2 July 2025

• Lauren Simmonds
Project Manager
Hawkes Bay Regional Council
159 Dalton Street
NAPIER 4110

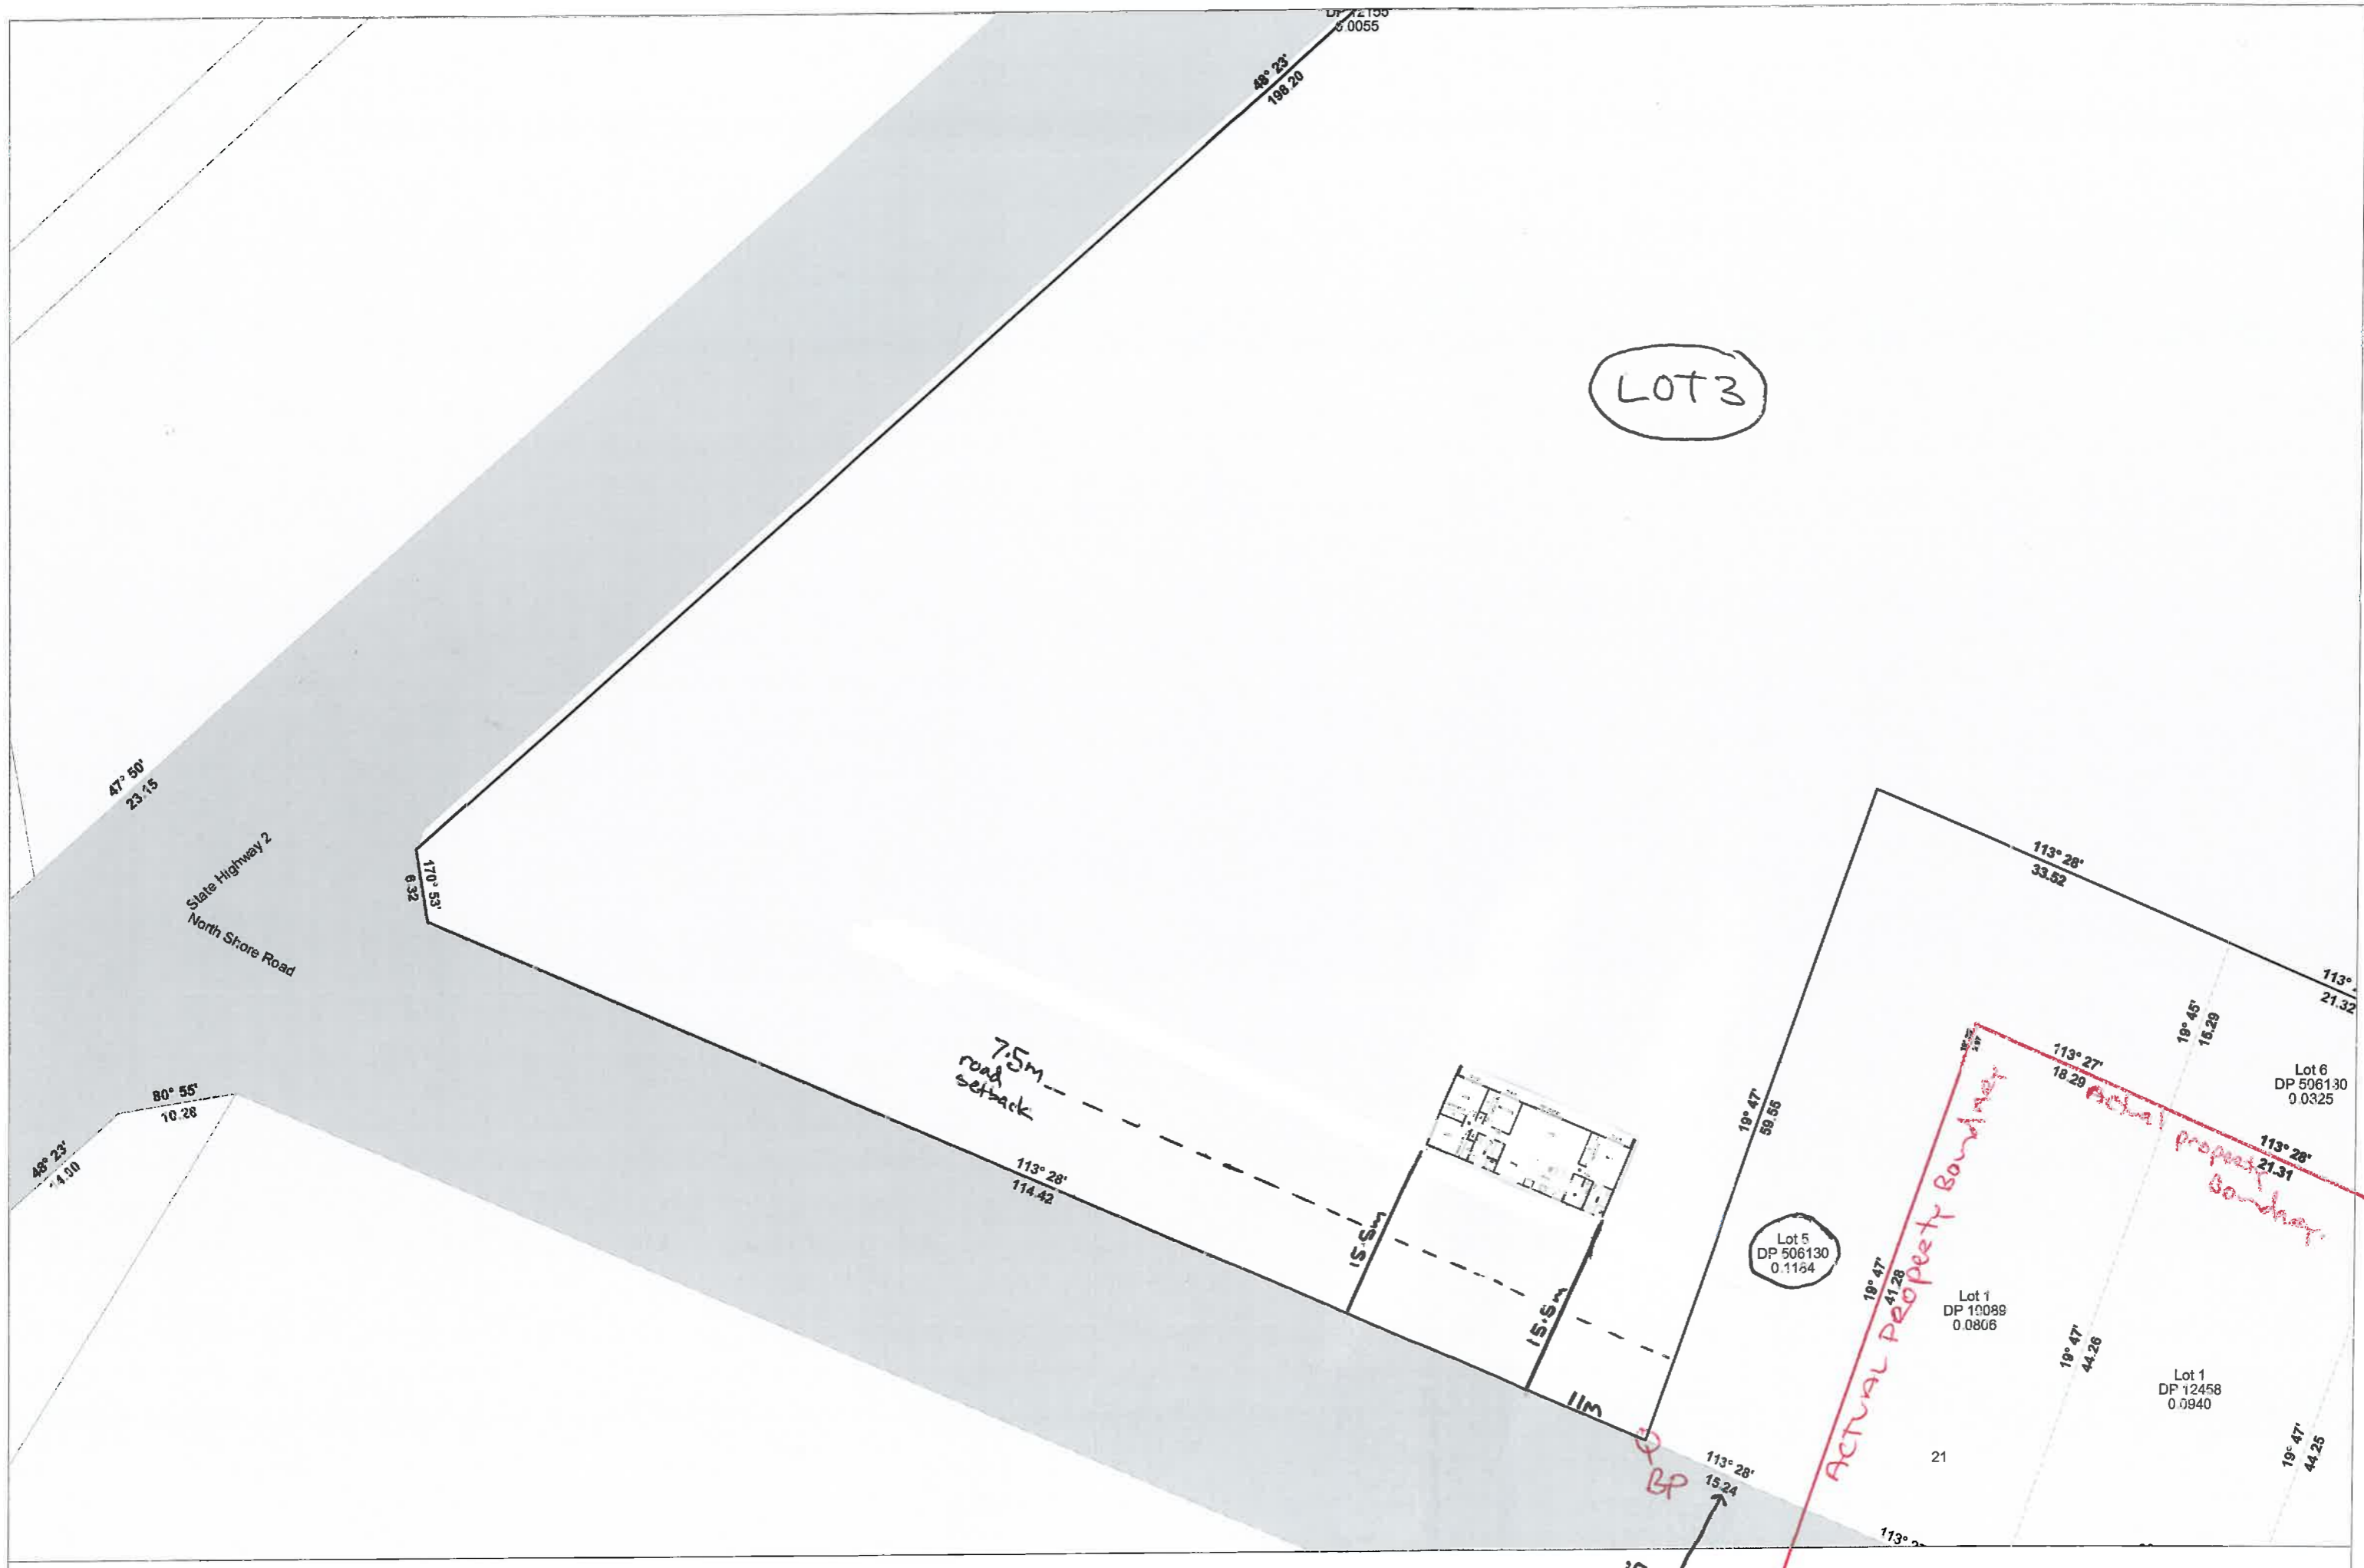
Engineering design and/or engineering design recommendations have been made based on the information provided to BCD. Should these recommendations be used for construction, BCD are to sight approved Building p:\22-1539 whirinaki transportable\060 bcd geotechnical\064 reports\issued\22-10-26 whirinaki transportable gar 22-1539 (minor update for rfi).docx
